May 28, 2020

Service Information Letter

Units Affected: Certain AT37-G and AT40-G aerial devices built from November 2017 to October 2018 (see attached list)

Torsion Bar Inspection on 60" CA Chassis

Figure 1 – Street Side Torsion Bar Assembly

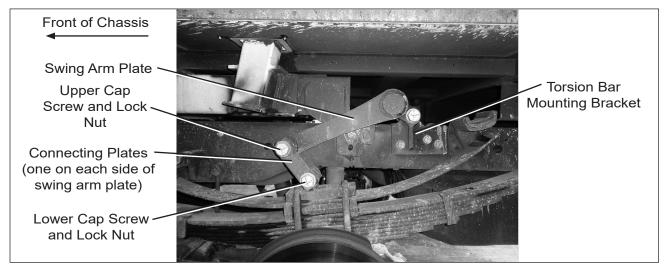
- 5. Look at the torsion bar assembly in the street side rear wheel, using a flashlight if necessary. If there is any dirt or debris on the swing arm plate, the connecting plates, or the upper lock nut and cap screw threads (refer to Figure 1), clean these components with soap and water or other suitable cleaning solution to ensure that any potential defects will be visible.

- 6. Using a flashlight and a mirror, inspect both connecting plates, the swing arm plate, and the upper lock nut and cap screw threads from all available angles. Look for any hairline cracks, bending, denting, or metal chipping.

Figure 2 – View of Street Side Wheel Well

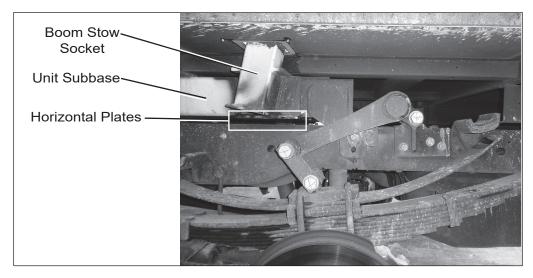
11. Locate the boom stow socket on the side of the subbase in the street side rear wheel well. Locate the horizontal plate under the boom stow socket (refer to Figure 2).

Figure 3 – Horizontal Plate Before Modification

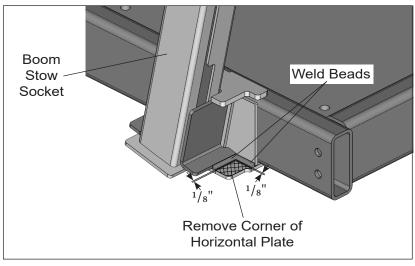
12. Using a plasma cutter or cut-off wheel, remove the corner portion of the horizontal plate beyond a distance of ¹/₈" from the edge of the weld beads, as shown in Figures 3 and 4. <u>Do not cut into the weld beads</u>. Do not cut into the horizontal plate any farther on the bottom than on the top if using a cut-off wheel.

Figure 5 – Shear Plates Located Incorrectly

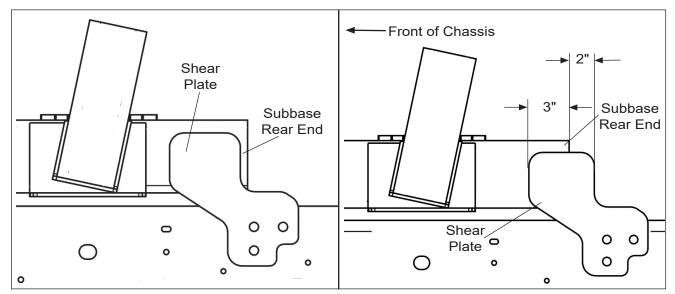
- 13. Locate the shear plate at the rear end of the subbase on each side.
 - If the shear plates are installed with the entire upper portion placed ahead of the rear end of the subbase as shown in Figure 5, modification is required. Proceed to step 14.
- If the shear plates are installed with the upper portion extending about 2" +/- 1" behind the rear end of the subbase as shown in Figure 6, no modification is required. Proceed to step 16.

14. If the shear plates are located incorrectly, a portion of each shear plate toward the front must be removed. Using a cut-off wheel, cut each shear plate vertically 2" from the front edge (refer to Figure 7). Using a grinder, remove the weld along the top and front edges of each shear plate. Do not cut into the side of the subbase tubing with the cut-off wheel or grinder. Complete the removal of this portion of the shear plates.
